**PARK COUNTY
PLANNING COMMISSION
RESOLUTION # 12-2016-01**

**A RESOLUTION RECOMMENDING APPROVAL OF AN APPLICATION FOR A
COMMON PLAT AMENDMENT TO REMOVE LOTS 1 THROUGH 29, TRACT 171
AND LOTS THROUGH 4, TRACT 159 (ADDRESSED AS 15674 SOUTH PITKIN
LANE) FROM WANDCREST PARK, THIRD FILING.**

Re: GUERRERO PLAT AMENDMENT
Case No.: 16AMN-01

LOT CONSOLIDATION AND COMMON PLAT AMENDMENT PLAT

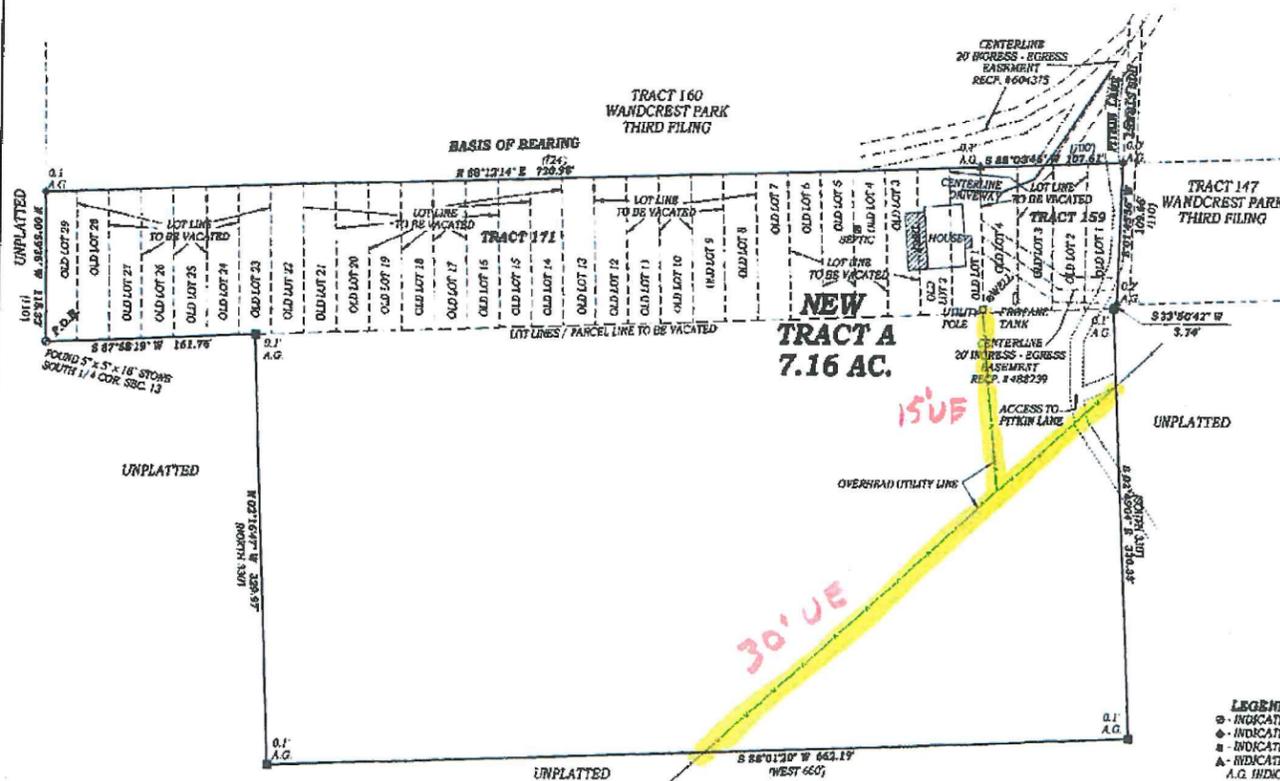
The Association has existing overhead electric facilities on the subject property. The Association will maintain these existing utility easements and facilities unless otherwise requested by the applicant to modify them under the Association's current extension policies.

As part of consolidating the lots and encumbrances; the Association existing overhead electric facilities are installed on those lots being requested to be consolidated. The existing overhead electric facilities were installed in 1939 and the Association has on hand an unrecorded blanket easement granted by the Nickel's on November 9, 1939.

The Association is requesting that as part of the Plat Amendment process that the applicant defines the existing overhead electric facilities. The Association is requesting a fifteen-foot (15') wide easement and a thirty-foot (30') wide easement as shown on the markup of the plat. In return, the Association will release the unrecorded blanket easement granted by the Nickel's.

1. Prior to hearing of the application by the Board of County Commissioners, utility easements as described in the letter from IREA attached as **Exhibit A** are added to the plat.
